Access Compliance Report

Public Rights-of-Way

(Pedestrian Signals)

Intersection ID: N/A	Main Street:	Cross Street: N/A	Location: N/A
ADA ID: 332F6E6619D1	Signal Type: One Push Button-APS	Overall Compliance: No	Severity Score: BTN 1: N/A BTN 2: N/A No BTN: N/A
Codes/Mitigation Info/Possible Solution		Field Measurements/Component Compliance

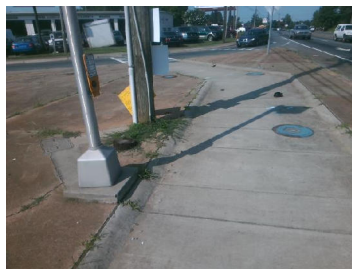
Surveyor Notes: TEXT HT 5/16

PROW/ADA: R410.6, TMUTCD 4e.08, R406.2, R404.7.3, R209.1, MUTCD 4e.10

Compliance	Description	Data	Compliance	Description	Data
	Button Count	Button1	N/A	Distant to Additional Button (in)	N/A
	Additional Button Present?	No		Additional Button ID	N/A
N/A	Signal Buttons Required?	N/A	N/A	Additional Ped Posts Required	N/A
	How Many Ped Street Xings?	2		Located In An Island/Median?	Yes
N/A	B 1 Sign Present?	Yes	N/A	B 2 Sign Present?	N/A
Yes	B 1 Sign Purpose?	Yes	N/A	B 2 Sign Purpose?	N/A
No	B 1 Sign Lettering & Contrast?	No	N/A	B 2 Sign Lettering & Contrast?	N/A
Yes	B 1 Parallel To XWalk?	Yes	N/A	B 2 Parallel To XWalk?	N/A
Yes	B 1 PAR to Button?	Yes	N/A	B 2 PAR to Button?	N/A
Yes	B 1 PAR to XWalk?	Yes	N/A	B 2 PAR to XWalk?	N/A
Yes	B 1 Clear Floor Space?	Yes	N/A	B 2 Clear Floor Space?	N/A
N/A	B 1 FWD Approach?	Yes	N/A	B 2 FWD Approach?	N/A
N/A	B 1 FWD Approach Constrained?	No	N/A	B 2 FWD Approach Constrained?	N/A
No	B 1 FWD Approach Reach (in)	18.0	N/A	B 2 FWD Approach Reach (in)	N/A

N/A	B 1 FWD Approach Width (in)	N/A	N/A	B 2 FWD Approach Width (in)	N/A
N/A	B 1 FWD Approach Obstruction?	Yes	N/A	B 2 FWD Approach Obstruction?	N/A
N/A	B 1 FWD Approach Obstruction Dist (in)	10.5	N/A	B 2 FWD Approach ObstructionDist (in)	N/A
N/A	B 1 PARA Approach?	Yes	N/A	B 2 PARA Approach?	N/A
N/A	B 1 PARA Approach Constrained?	No	N/A	B 2 PARA Approach Constrained?	N/A
No	B 1 PARA Approach Reach (in)	18.0	N/A	B 2 PARA Approach Reach (in)	N/A
N/A	B 1 PARA Approach Width (in)	N/A	N/A	B 2 PARA Approach Width (in)	N/A
N/A	B 1 PARA Approach Obstruction?	Yes	N/A	B 2 PARA Approach Obstruction?	N/A
N/A	B 1 PARA Approach Obstruction Dist (in)	10.5	N/A	B 2 PARA Approach ObstructionDist (in)	N/A
Yes	B 1 Clear Floor Space Slope (%)	0.9	N/A	B 2 Clear Floor Space Slope (%)	N/A
Yes	B 1 Clear Floor Space XSlope (%)	1.2	N/A	B 2 Clear Floor Space XSlope (%)	N/A
N/A	B 1 PAR Slope (%)	1.0	N/A	B 2 PAR Slope (%)	N/A
Yes	B 1 Height (in)	47.0	N/A	B 2 Height (in)	N/A

Yes	B 1 Clear Xing Direction?	ClearlyMarked	N/A	B 2 Clear Xing Direction?	N/A
	B 1 Crossing Direction	To NE		B 2 Crossing Direction	N/A
Yes	B 1 DistanceTo XWalk (in)	10.0	N/A	B 2 DistanceTo XWalk (in)	N/A
No	B 1 DistanceTo Curb (in)	94.0	N/A	B 2 DistanceTo Curb (in)	N/A
Yes	B 1 Diameter (in)	2.0	N/A	B 2 Diameter (in)	N/A

Possible Solutions: Replace Signal Push Button With APS Button on New Post. Remove & Replace Sign.
